Item 5.

Post Exhibition - Planning Proposal - 2 Chifley Square, Sydney - Sydney Local Environmental Plan 2012 and Sydney Development Control Plan 2012 Amendment

Figure 7: Requested change to eastern setback of planning envelope

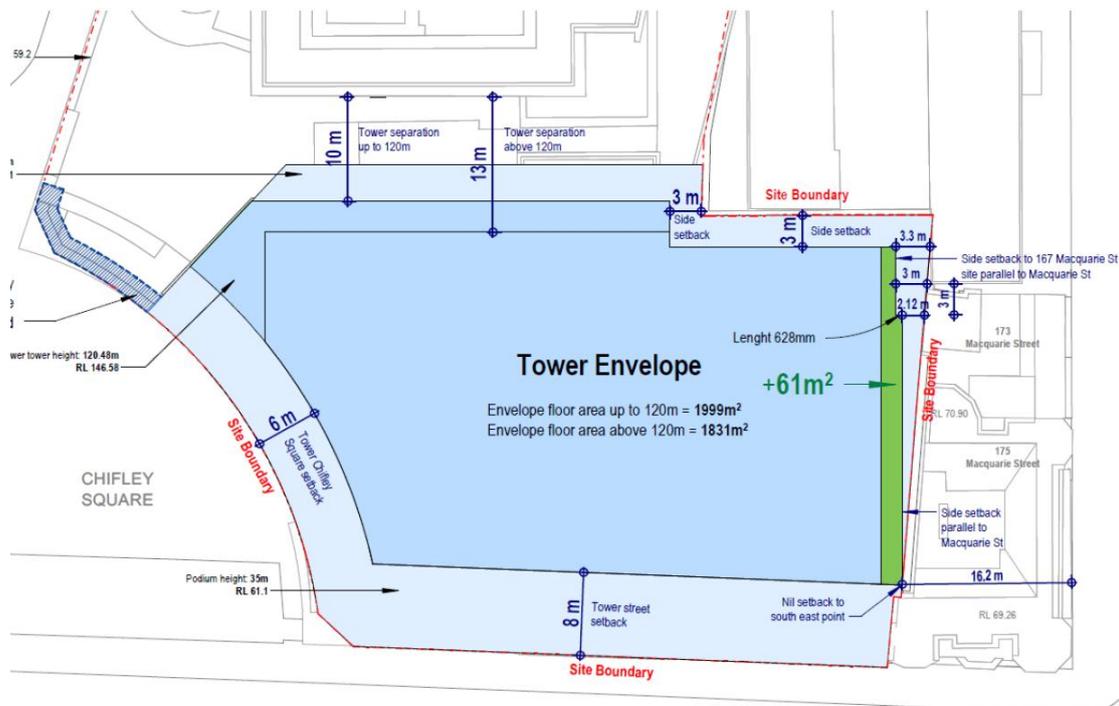
- 42. The proponent, Charter Hall, requested a reduction of the eastern setback of the planning envelope, from 2m - 4.7m to 0m - 3.3m, as shown in the plan at figure 7 below. The change is not supported for the reasons discussed below.
- 43. The additional area of the envelope resulting from the requested reduced setback is depicted in green:

44. The plan shows this reduction in setback would result in an additional 61sqm of floor area, or a total increase 1,026sqm for the whole planning envelope, although this does not factor in building efficiency and articulation allowances.

45. The Central Sydney planning controls allow for setbacks to be reduced subject to there being no overall reduction in amenity (wind and sky view) in public places, and that urban design outcomes are still achieved. The request to reduce the eastern setback was accompanied by sky view factor and wind reports, to demonstrate that the proposed envelope would result in a better outcome in the public domain compared to the base case envelope.

46. Urban design and heritage impacts were a key consideration in the assessment of a suitable planning envelope on this part of the site. In response to concerns raised by the Design Advisory Panel (DAP) about the original proposed envelope, a DAP subcommittee was formed. One of the key issues considered were setbacks, including tower envelope setbacks to the eastern boundary to provide for appropriate building separation, and separation of massing to the two local heritage items at 171-173 and 175-181 Macquarie Street known as 'Horbury House' and 'Wyoming'. The eastern setback of the planning envelope was also established to be sympathetic to the building alignment in Macquarie Street, and provide for a built form to support attractive streetscapes with high amenity. The 2 metre setback was seen as a minimum, as the DAP subcommittee had given consideration to an even greater setback to Macquarie Street for urban design and amenity outcomes.

47. Macquarie Street has important heritage significance, as it includes local, state, and world heritage items, and is included in the Macquarie Street Special Character Area. In addition, the Federal Government has proposed to include the Governors' Domain and Civic Precinct as part of the National Heritage List. This listing is proposed to include Macquarie Street, and Horbury House in particular. Part of the significance of this precinct is the development of Macquarie Street with its early colonial architecture as important milestones in the creation this distinctive civic precinct, with later buildings within the precinct continuing to respect the inherited civic intentions for this area. It is therefore considered that the setback of the planning envelope as exhibited should be retained in order to respect these important heritage considerations.

48. Although the owner of the property at 175-181 Macquarie Street, known as 'Wyoming' provided a submission supporting the reduced setback and advising they would support an easement for maintenance, it is not considered to outweigh the urban design and heritage impacts that would result from a reduced or nil setback from a heritage item.

Figure 9: Comparison of existing and potential view extents westwards from 60 Martin Place, Sydney

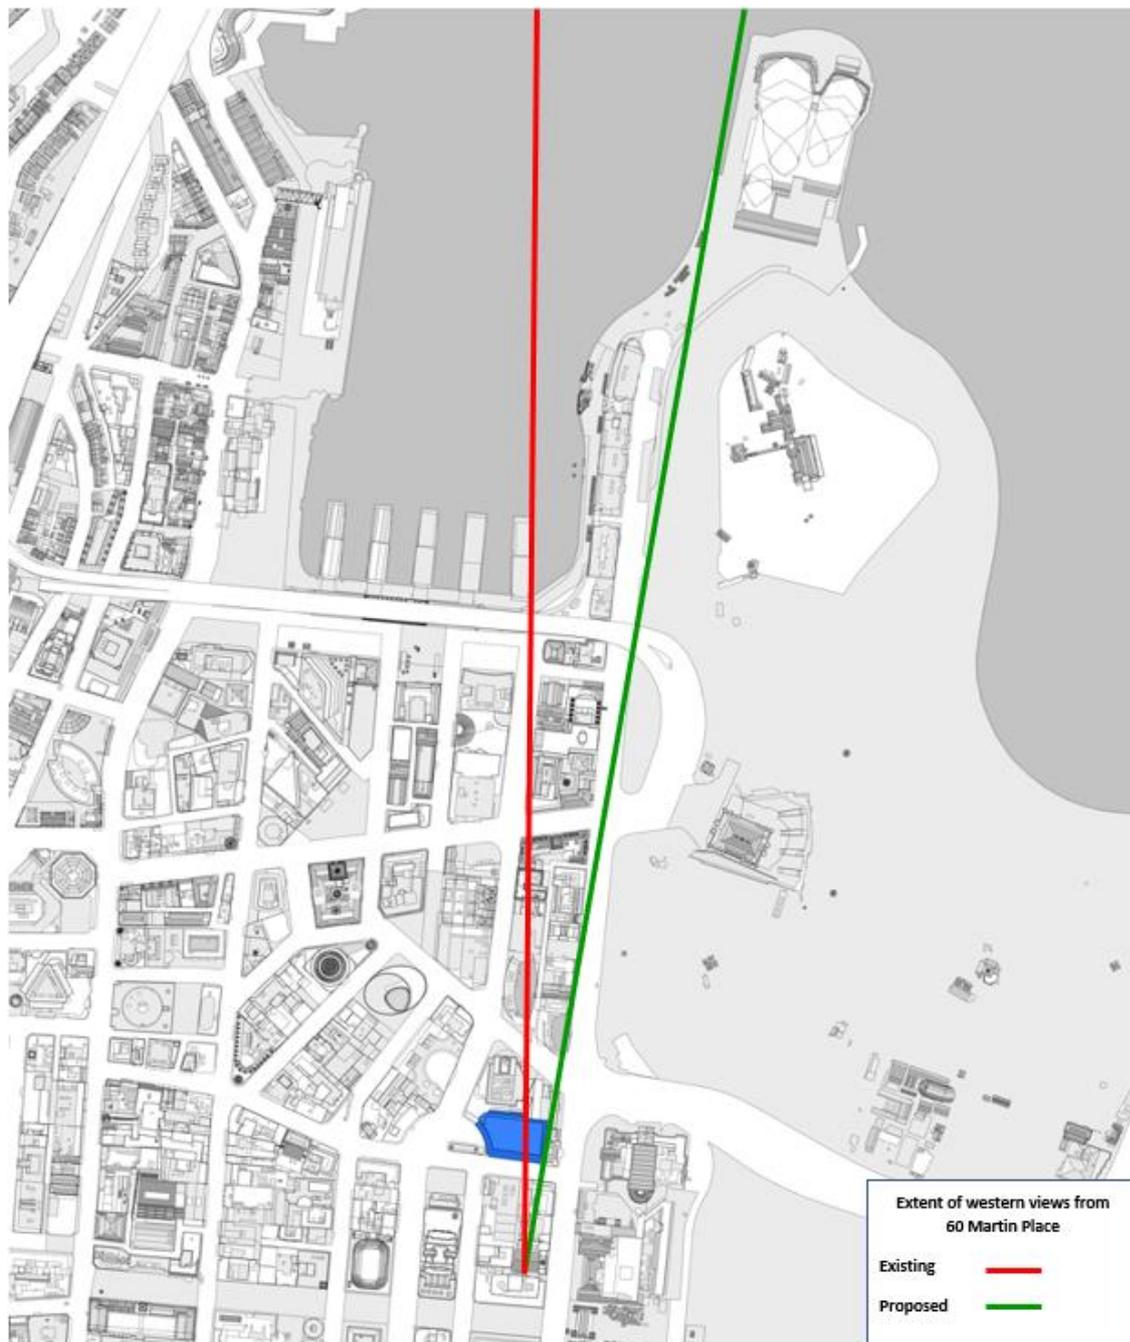
49. A submission was received from the owner of 60 Martin Place raising concerns that the eastern setback of the planning envelope approved by the Central Sydney Planning Committee and Council, of 2m - 4.7m should be increased to comply with the DCP requirement of 6.5m, and have chamfered corners, due to impacts on view loss from 60 Martin Place. The submission included a photo from level 21 of 60 Martin Place, at Figure 8, with the approximate extent of the proposed envelope shown, and potential view loss extent in red hatched area.

50. The Central Sydney Planning Strategy allows for setbacks to be reduced subject to there being no overall reduction in amenity (wind and sky view) in public places, and that urban design outcomes are still achieved. The proposed envelope did not require chamfered corners due to the sky view and wind testing of the envelope resulting in an improvement on the base case envelope, satisfying the requirements of the DCP.

51. The Central Sydney Planning Strategy prioritises views from public places but does not protect views from private places. Protecting private views in Central Sydney would constrain reasonable development that would help achieve the economic objectives for Central Sydney due to the density and heights of buildings.

52. The City's analysis of the existing and potential views from 60 Martin Place is at Figure 9. The existing views in a northerly and westerly direction from the location indicated in the submission are restricted by existing buildings including Chifley Tower, Deutsche Bank Place at 126-144 Phillip Street, and the building at 167 Macquarie Street. Although it is acknowledged that a small portion of existing views would be impacted by the proposed planning envelope, extensive scenic views of the Sydney Opera House, The Domain, the Harbour and distant views eastwards would be retained. The loss of views from 60 Martin Place are not considered to warrant an even greater setback to the eastern boundary than that endorsed by CSPC and Council.

53. It is also noted that the planning proposal and draft DCP provide an envelope that a future building will be contained within. The final tower form will be established through the architectural design competition.
